#2017-38 Mercyhealth Hospital Project Review for Planning and Zoning Commission

Meeting Dates: December 6, 2017 public introduction meeting and
January 3, 2018 public hearing

1. Preliminary Planned Unit Development for a micro-hospital and medical center.
2. Special Use Permit for a hospital and accessory uses including helipad.
3. Deferral to bury existing overhead utility lines until an area wide program is established.

Location: 875 Route 31

Helipad Diagram

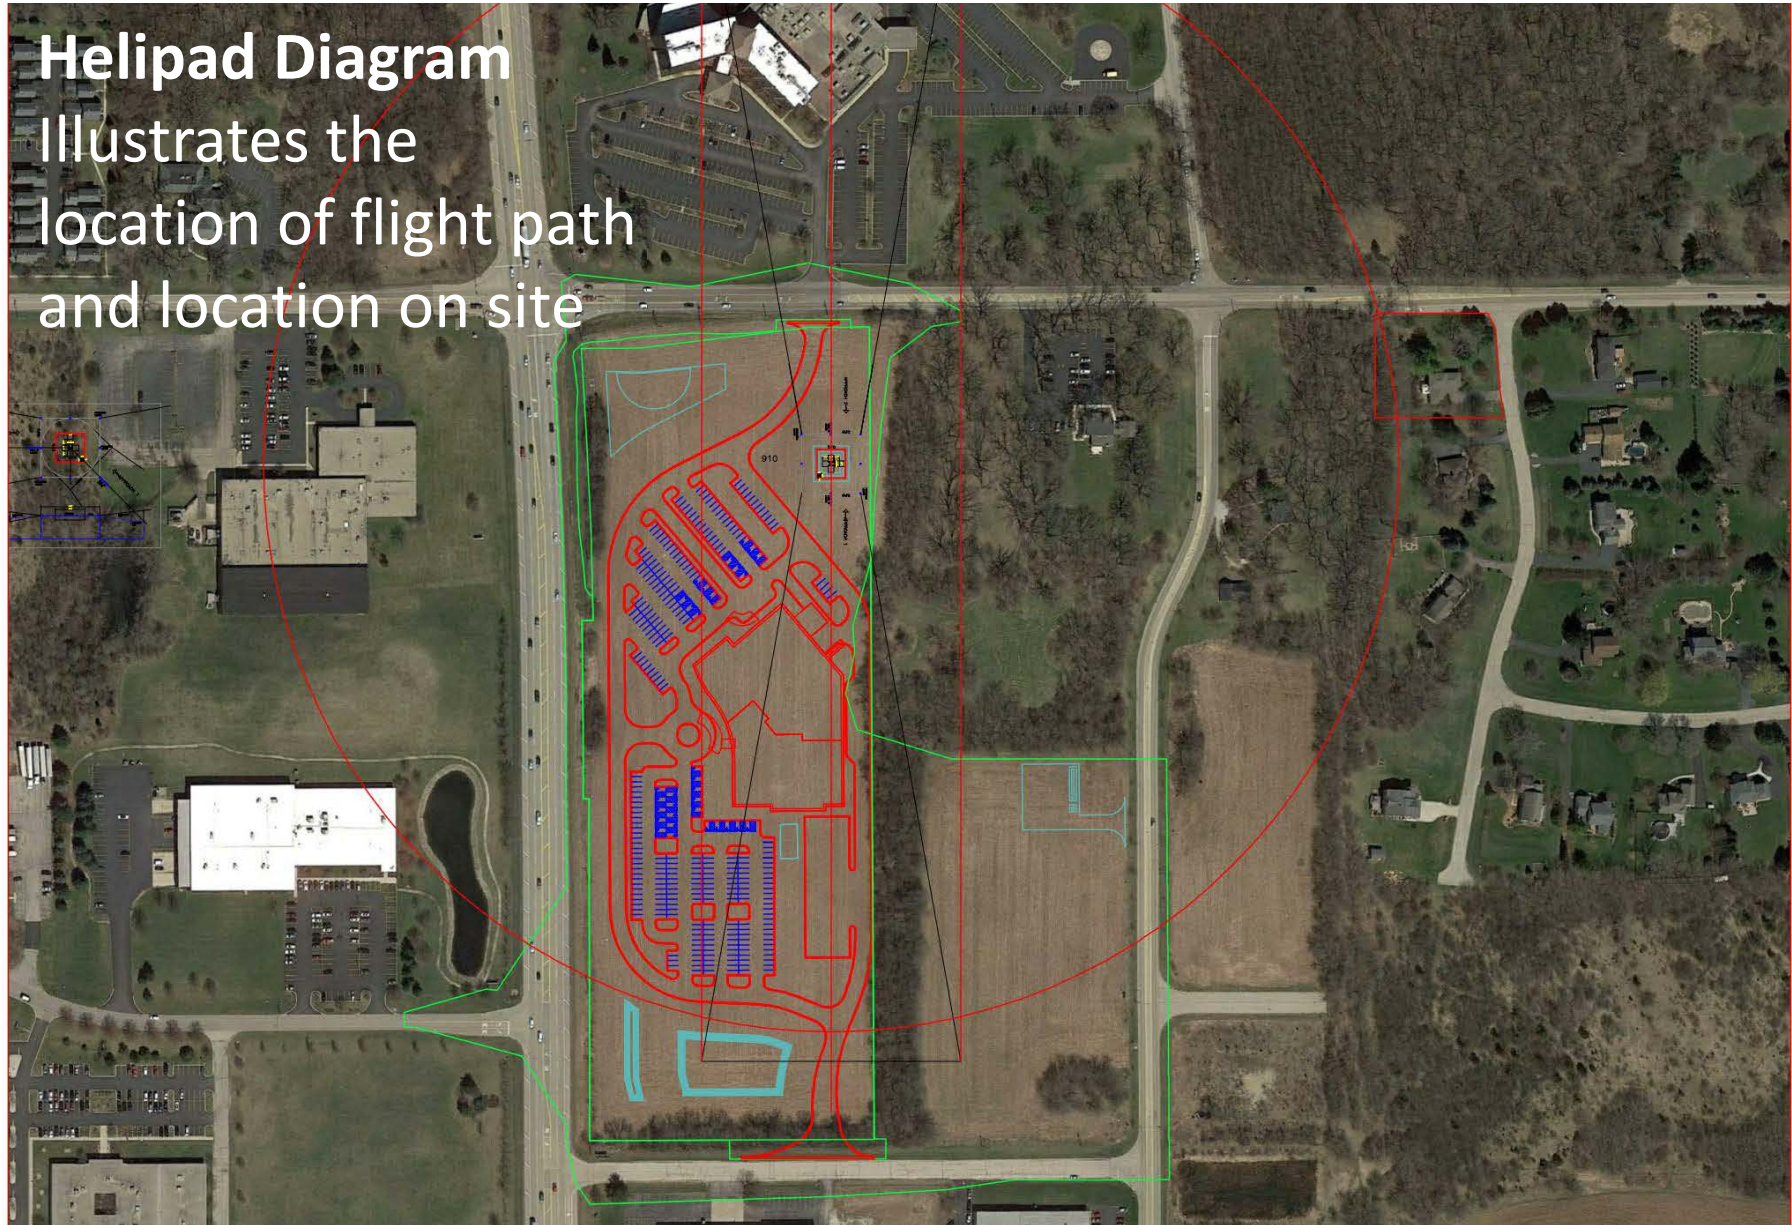
- The site is situated between Route 31 and Three Oaks Road and Raymond Drive.
- The hospital is located along the west side of the site on the northern half of the property with parking around the building.
- Internal circulation around the building is provided through the parking lot and a dedicated drive aisle in both the front and rear of the site.
- The helipad is located at the northeast corner of the site, due to the required flight path this is the only feasible location.

6. Submit the IDOT approval for the helipad.
7. The project plans for Final PUD must incorporate the recommendations contained in the traffic study. In addition, the site plan shall be reworked and no permanent obstructions created to allow for the future realignment of Raymond Drive so that it lines up with Tek Drive. The petitioner shall pay their fair share of the potential future traffic signal at the Rt 31/Raymond/Tek Drive intersection.

CONCEPTUAL SITE PLAN

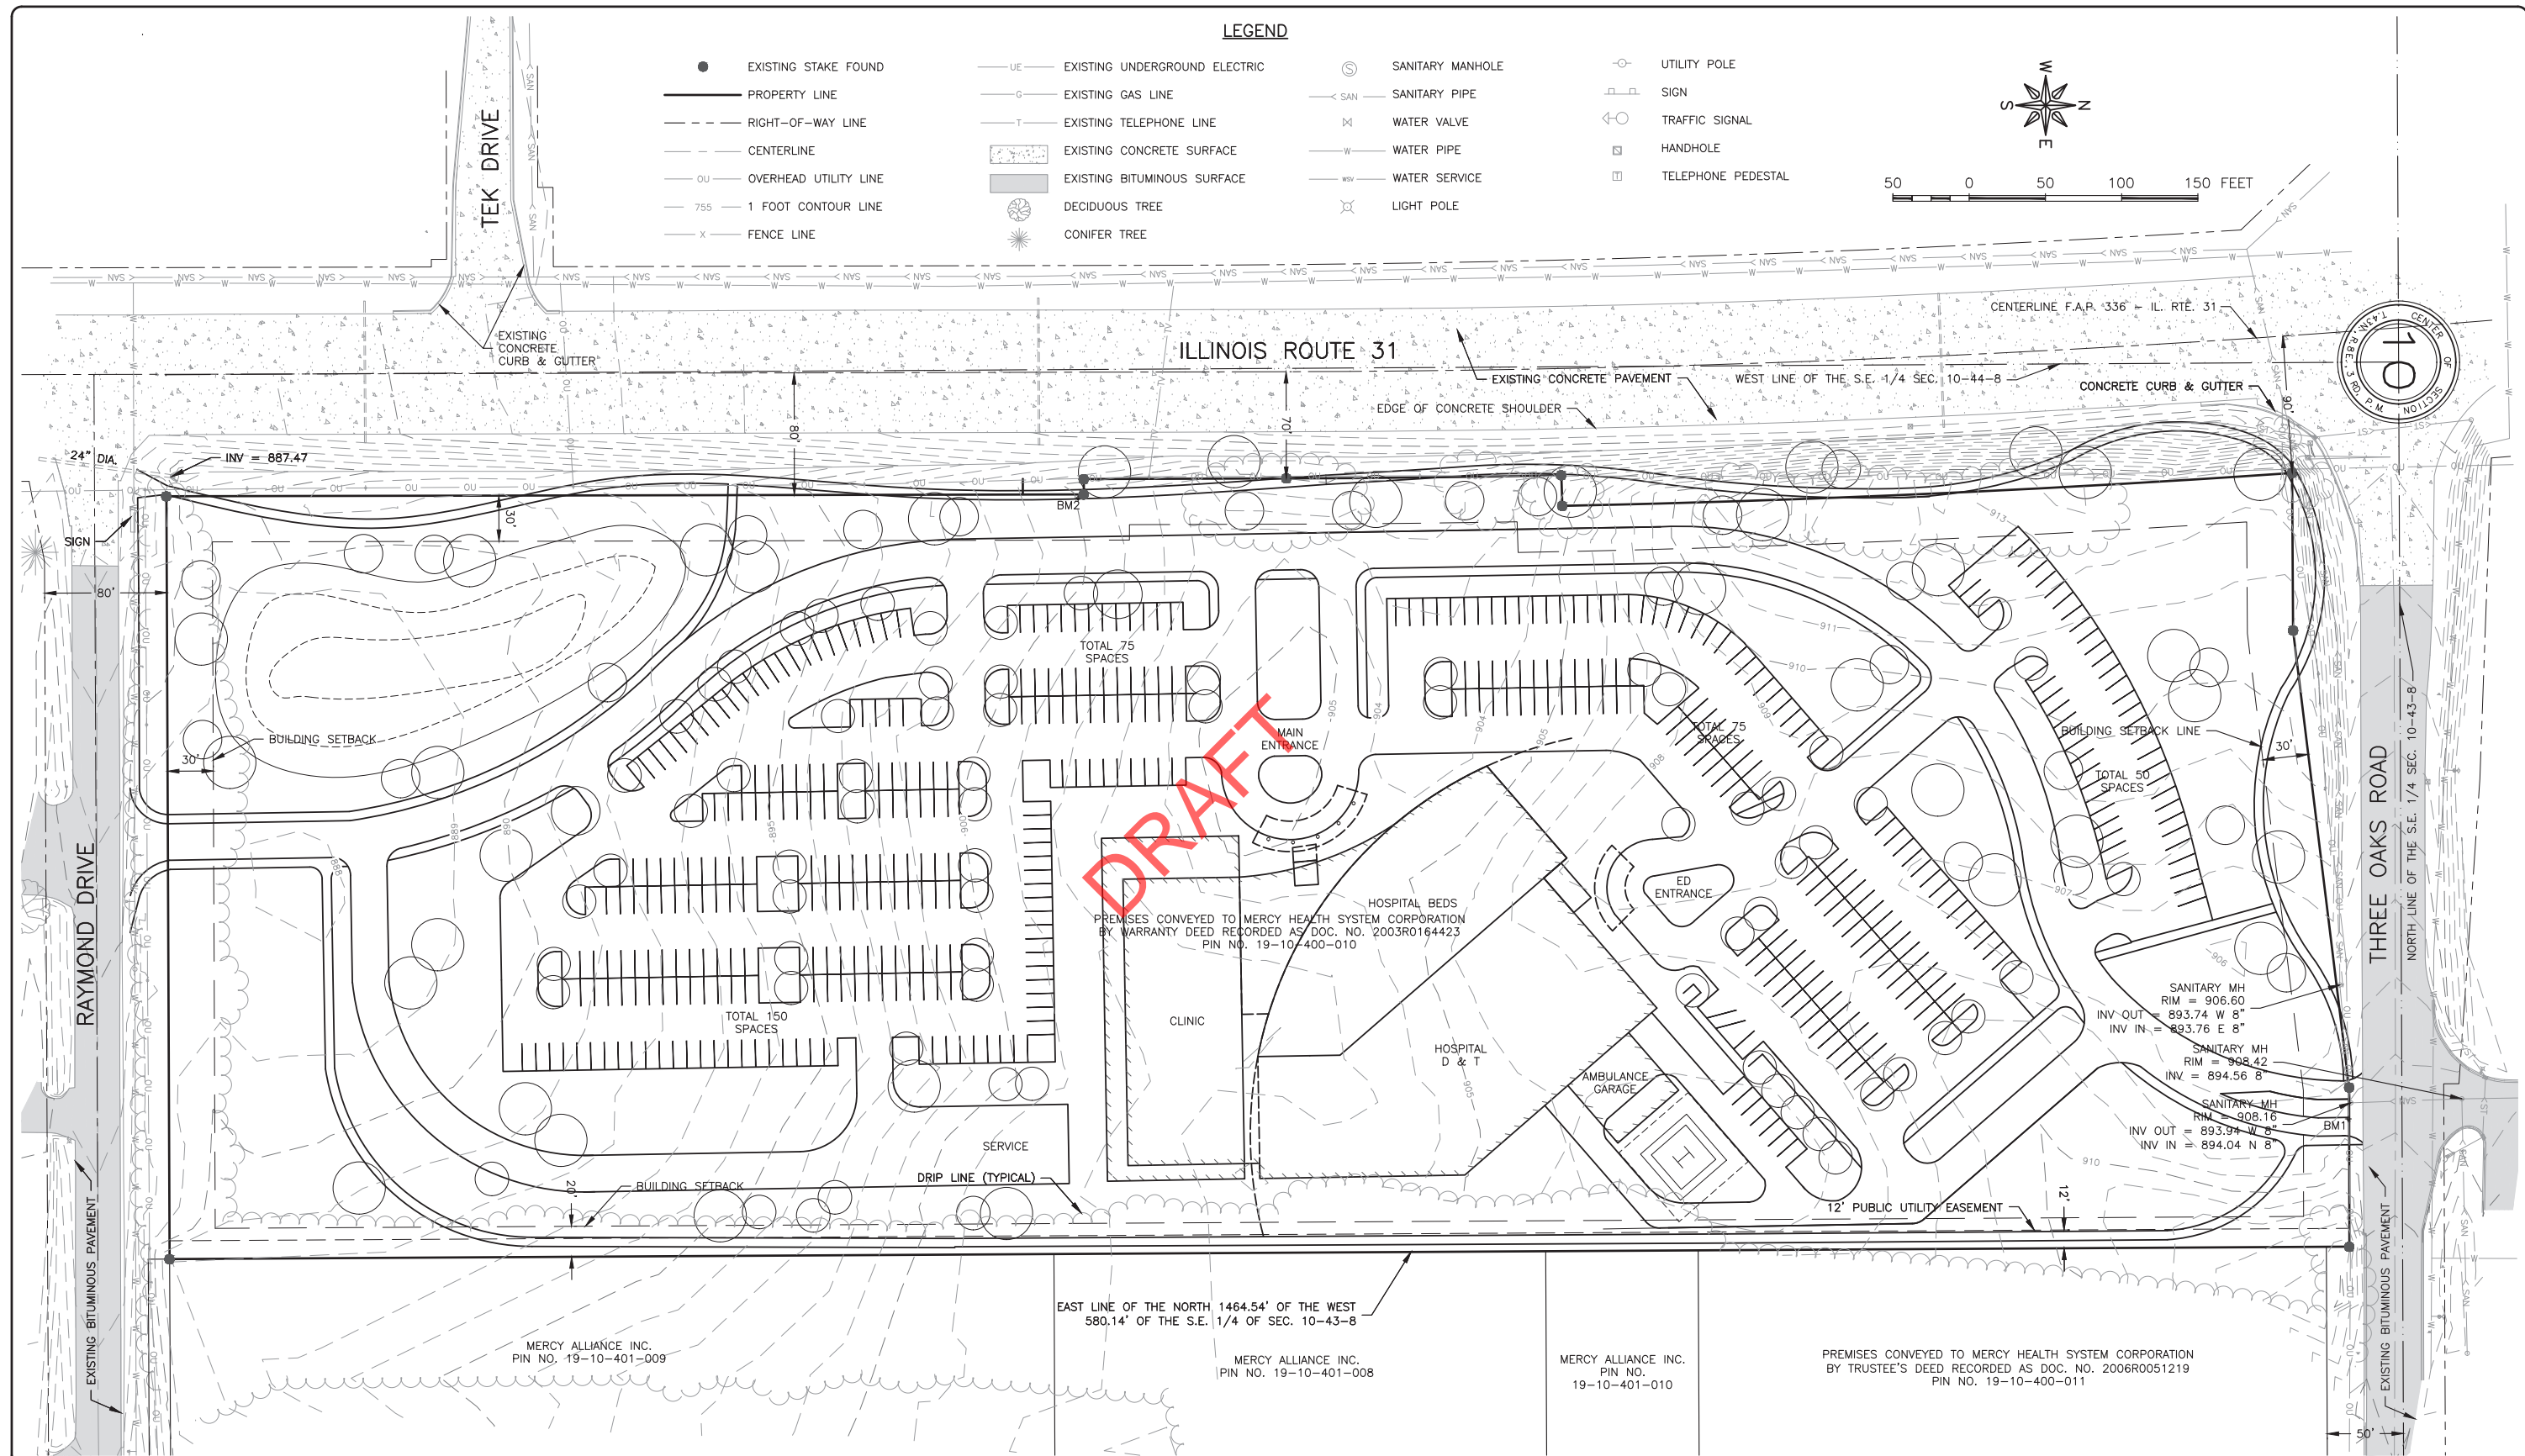
It is anticipated that as the currently undeveloped parcels located east of the proposed site are developed in the future, safety and operational concerns will necessitate the realignment of Raymond Drive such that it forms the east leg of the existing IL 31/Tek Drive intersection. While there are no current plans for the realignment of Raymond Drive, the site layout for the subject development should be designed so as to not preclude this potential realignment, which is key to future operations and potential signalization.

Regardless of the final configuration of the intersection geometrics, several additional items should be taken into consideration when preparing site and roadway improvement plans for the subject development. If alterations to the site plan or land use should occur, changes to the analysis provided within this traffic impact study may be needed.
